Bulletin No.: P11097A

**Subject:** Intermittent Service Power Steering Message on DIC, DTC C0544 Set

**Models:** 2013-2014 Cadillac ATS

3648055

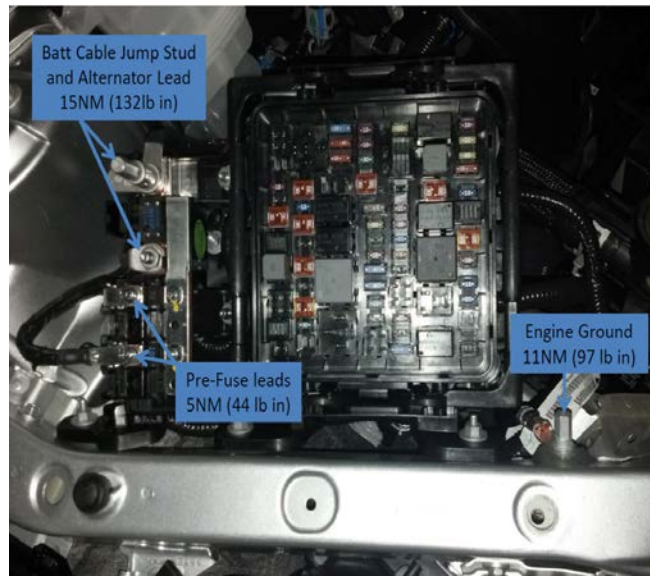
1. Inspect the underhood fuse block power and ground connections for proper torque as identified in the above photo.
2. Inspect the X1, X2 and X3 connectors at the Power Steering Control Module (steering gear) for damaged or spread terminals on the vehicle harness or on the Power Steering Control Module. Ensure the connectors are completely seated.

3575838

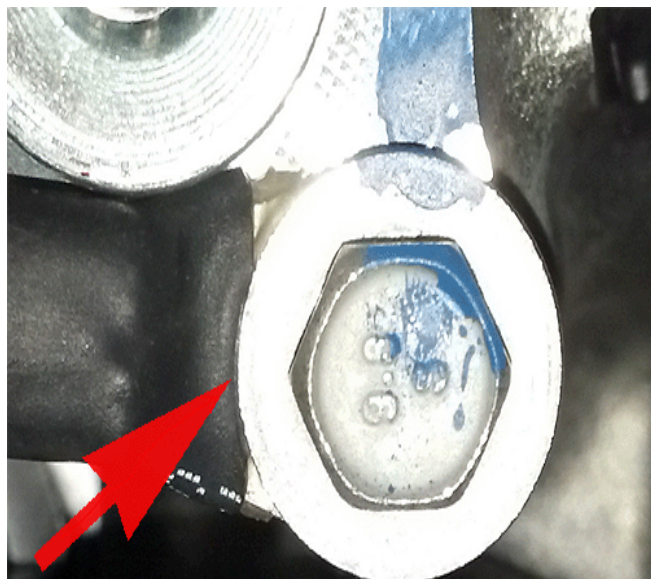
3. **For 2013 Model Year vehicles only**, inspect engine ground #G104, verify the torque and ensure the connection is clean and sound.

Look for either excess shrink wrap or glue under the eyelet. Inspect for adhesive that has seeped out onto the eyelet during the heating of the shrink tube, or the shrink tube itself extending into the eyelet area.

**Important:** It is not an adequate check to simply try to wiggle the ground wire to check for looseness. The ground must be removed and checked for these items, cleaned and reinstalled.

4. Carefully trim the heat shrink tube if needed, clean adhesive from the eyelet (sand off), reinstall and torque.
